Access Compliance Report Public Rights-of-Way (Curb Ramps)

Main Street: N/A Cross Street: RED_HILL_AVE Location: N

ADA ID: RPRK220107114300 Ramp Type: Type 6 - Directional 1 Initial Pass/Fail: Fail Overall Compliance: No Severity Score: 15

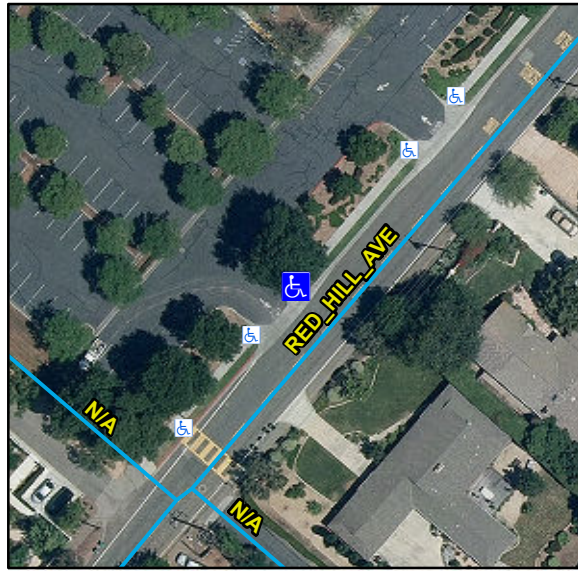
Compliance	Description	Data	Compliance	Description	Data
N/A	Ramp Length (in)	114	N/A	Flare Type LT	
Yes	Ramp Width (in)	58			N/A
No	Ramp Run Slope (%)	8.5	N/A	Flare Slope LT (%)	N/A
Yes	Ramp Cross Slope (%)	2.8	N/A	Flare Traversable LT	N/A
N/A	Grade Break	N/A	N/A	Flare Type RT	
N/A	Grade Break Slope (%)	N/A			N/A
N/A	Grade Break Cross Slope (%)	N/A	N/A	Flare Slope RT (%)	N/A
	Addl Para Ramp Left?	No	N/A	Flare Traversable RT	N/A
	Addl Para Ramp Right?	No	N/A	DWS Provided	N/A
N/A	Landing Present	N/A	N/A	DWS Contrast	N/A
N/A	Landing Length (in)	N/A	N/A	DWS Length (in)	N/A
N/A	Landing Width (in)	N/A	N/A	DWS Full Width	N/A
N/A	Landing Run Slope (%)	N/A		DWS Offset Type	N/A
N/A	Landing Cross Slope (%)	N/A	N/A	DWS Left Offset (in)	N/A
N/A	Landing Movement Obstructed?	N/A	N/A	DWS Right Offset (in)	N/A
	Landing Movement Type	N/A			
N/A	Landing Shared	N/A			
N/A	Marked Crosswalk 1	No	N/A	Clear Space	N/A
	Crossing 1 Direction	SW	N/A	Clear Space To Crosswalk (in)	N/A

Remove & Replace Entire Ramp.

R304.2.2, STD 1115
